Affected Publication: API Specification 5B, *Threading, Gauging, and Inspection of Casing, Tubing, and Line Pipe Threads*, 16th Edition, December 2017

Addendum 1

Figure 58—8 Round Casing Thread Ring Standoff

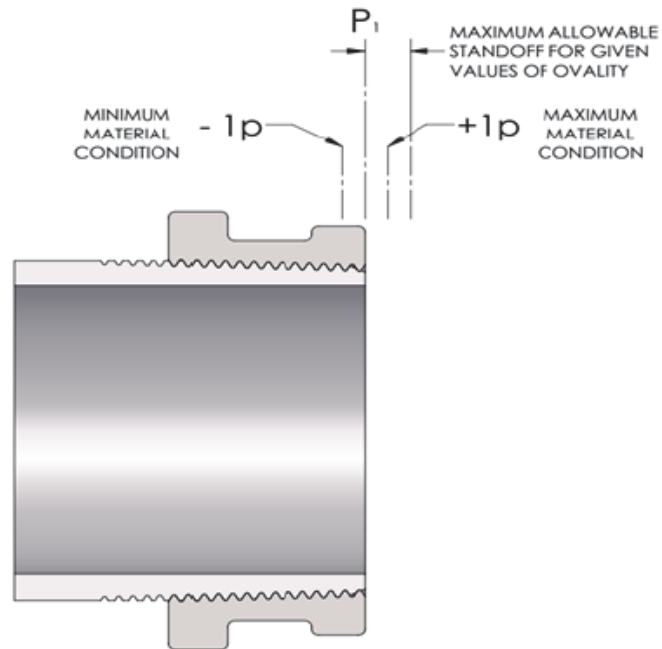
Figure 58: The figure shall be replaced with the following:

NOTE See 6.1.8 and 6.1.9 for additional stand-off adjustments due to ovality.

Figure 59—8 Round Casing Thread Plug Standoff

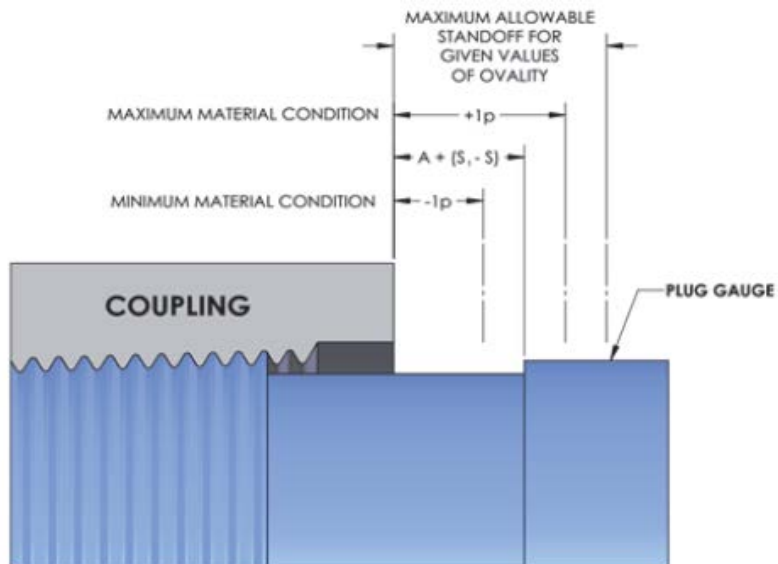
Figure 59: The figure shall be replaced with the following:

NOTE See 6.1.8 and 6.1.9 for additional stand-off adjustments due to ovality.
